GENERAL APPLICATION

TAC SUBMISSION
 6/5/2023
 REVISION No.1 02/26/2024

THE GEORGE
 950 S FEDERAL HIGHWAY
 HOLLYWOOD, FLORIDA

Drawing Title
LEVEL 1 - FLOOR PLAN
Client Name *Kreta Holdings LLC*
Project Number *2208*
Date *6/5/2023*
Approved by *NMD NOMADAS*
Scale *As indicated*
Drawing Number

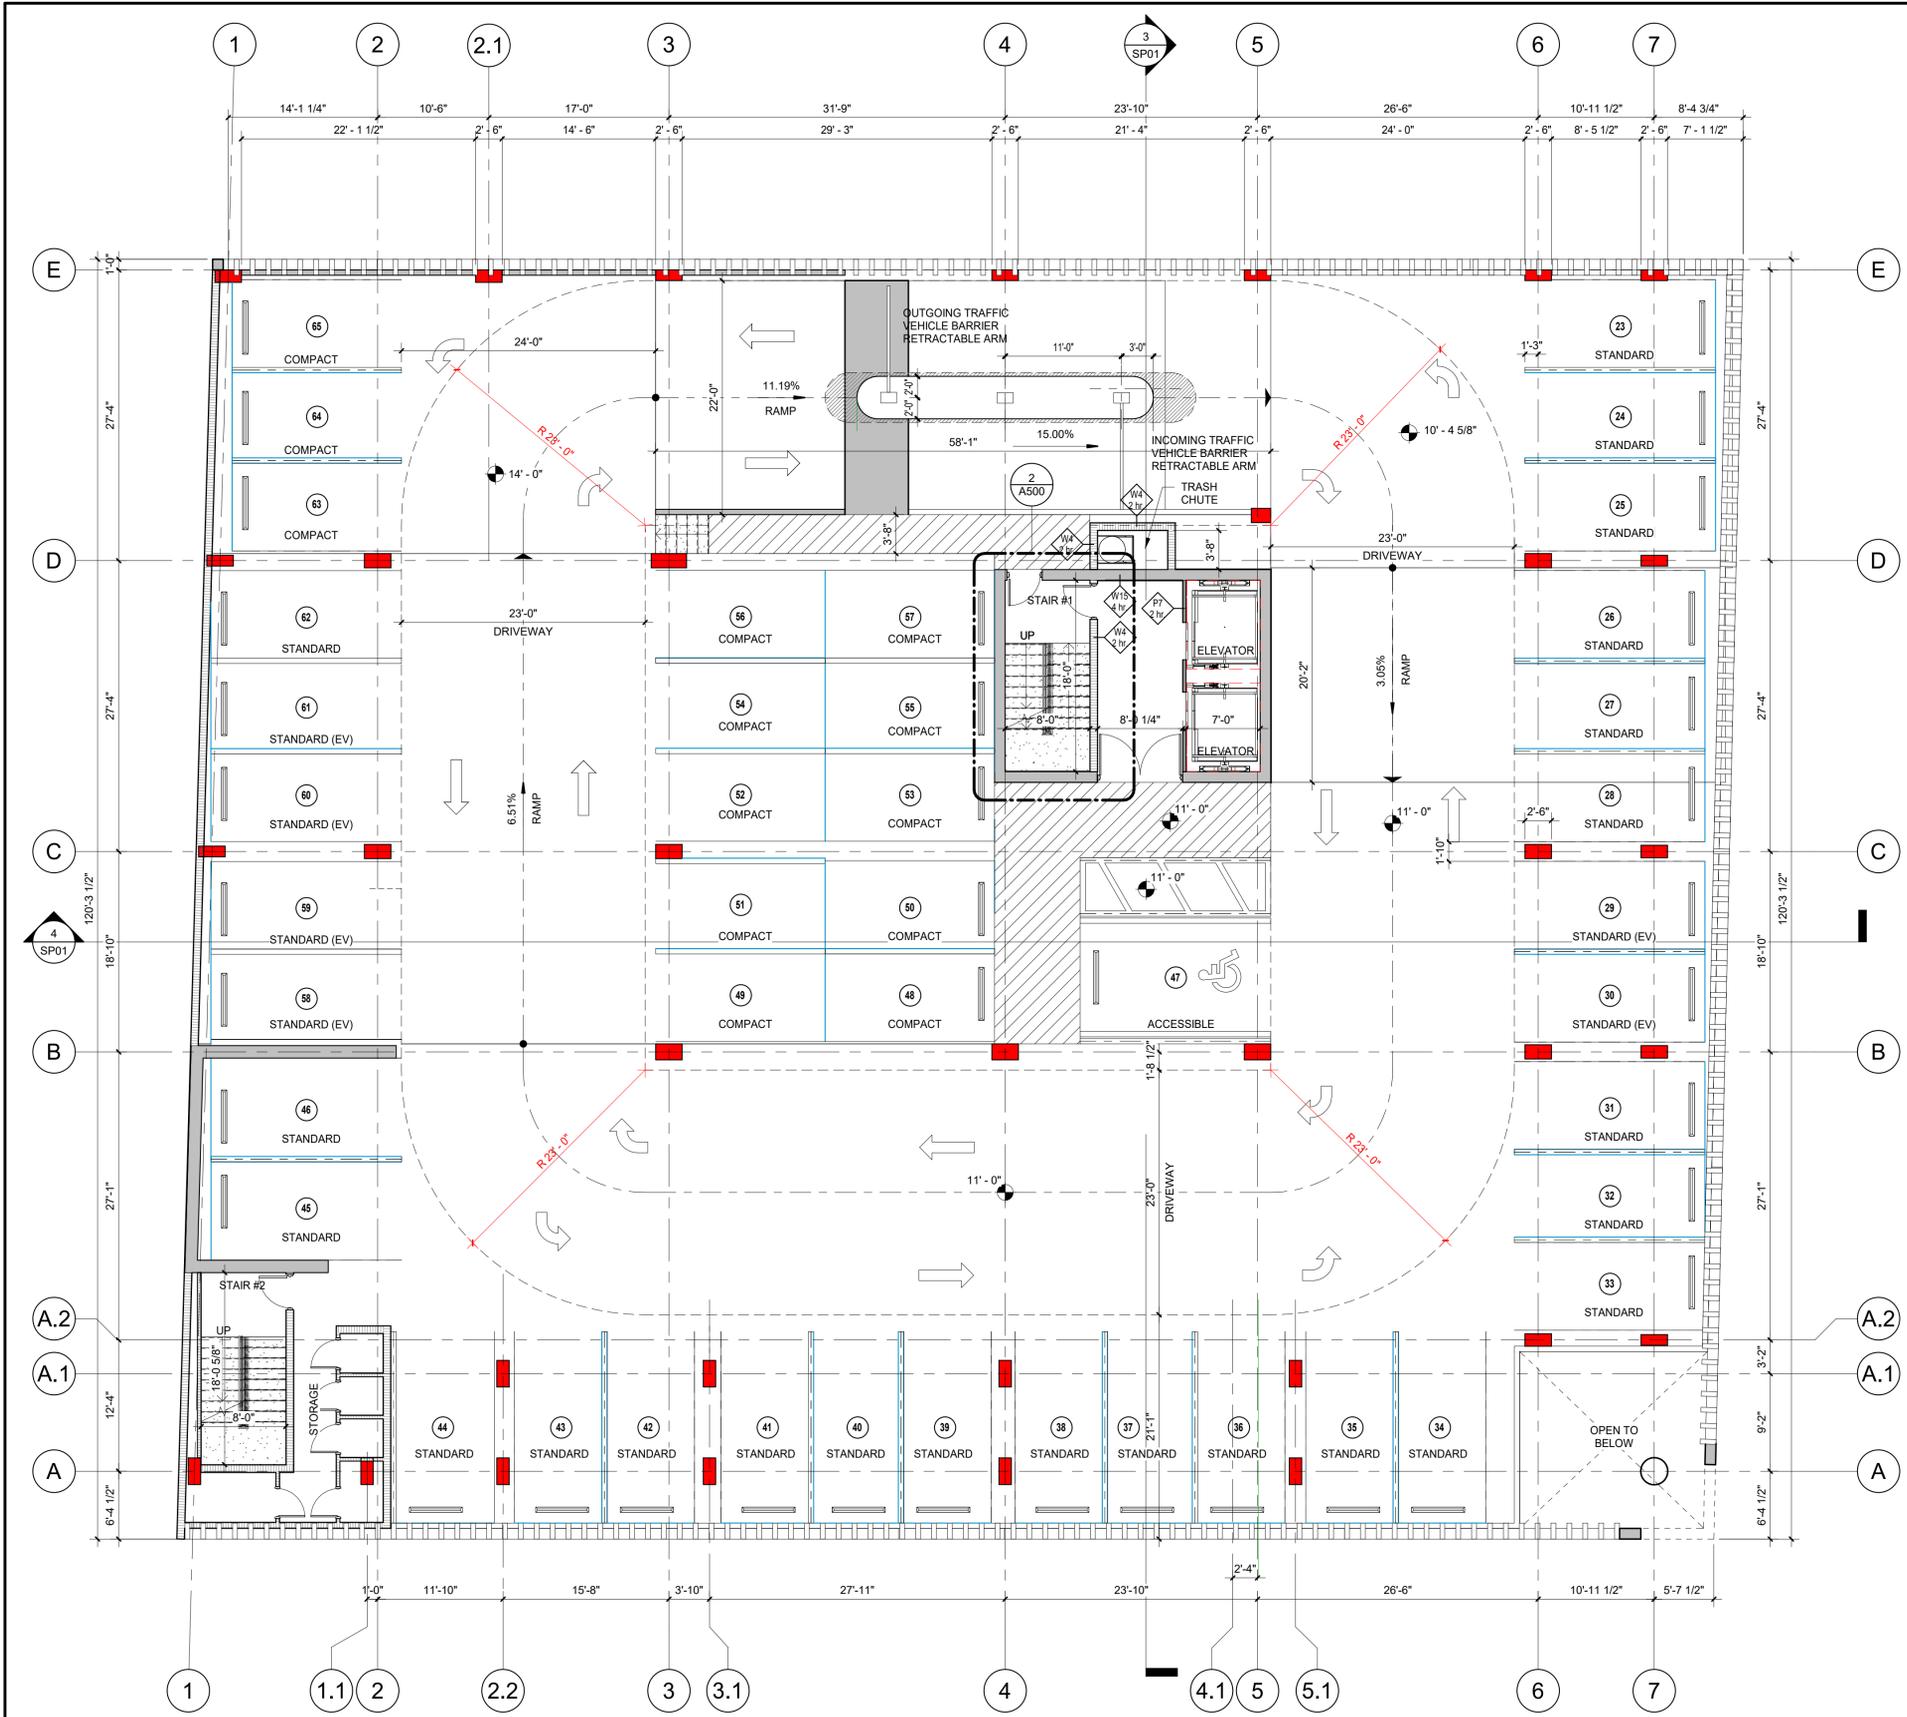
11. Sheet A101 shows garage ramp is for Down only.

12. Sheet A101, label the intended use for all spaces and rooms (i.e. room across from the elevators and room between parking stalls 19 and 20). In addition, label the stairs and elevators.

13. Label Trash Chute on all floor plans and identify and label on Sheet A101.

16. Sheet A101, label property lines.
